DRAWING TITLE
BLDG 2 THIRD FLOOR PLAN - AREA E2

PROJECT TITLE
SLVHCS REPLACEMENT MEDICAL
CENTER PROJECT

2A103-E2

1 BLDG 2 THIRD FLOOR PLAN - AREA E2
SCALE: 1/8" = 1'-0"
SEE PREVIOUS SHEET FOR FLOOR PLAN LEGEND

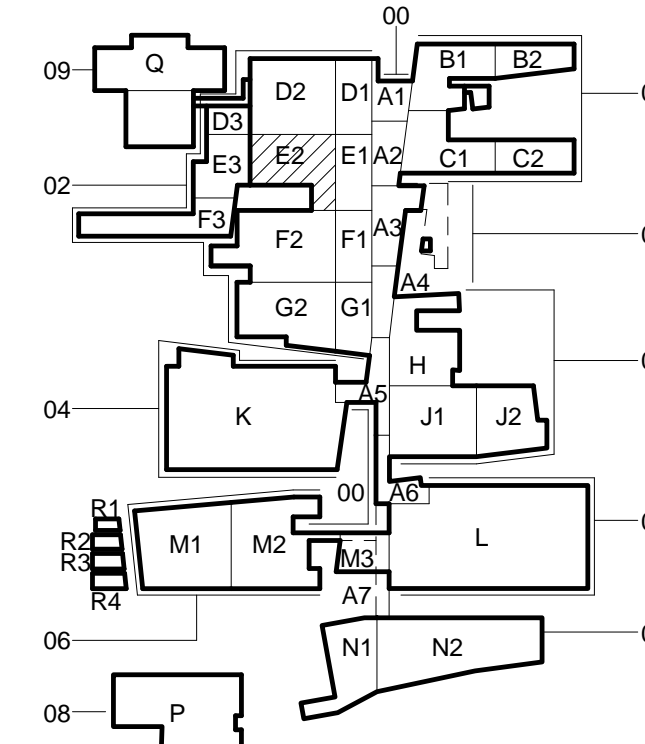
REFER TO THE FOLLOWING SKETCH FOR CHANGES:
SK-8-4-NJ 2A1003

RFI 06675: See RFI sketch for framing detail of false column.

RFI 07212 and 07212.1: All exterior walls where J-4 walls were deleted and more than 3/4" of fire safing is exposed to be handled per RFI.

INTERIOR BACK-UP WALL, OPENINGS, SOFFITS, ETC. AROUND PERIMETER OF BUILDING REVISED TO COORDINATE W/ EWP-06 SKIN COST REDUCTIONS. NEW AND/OR REVISED PLAN/SECTION/ROOF DETAILS AS INDICATED ON PLANS AND REFLECTED CEILING PLANS.
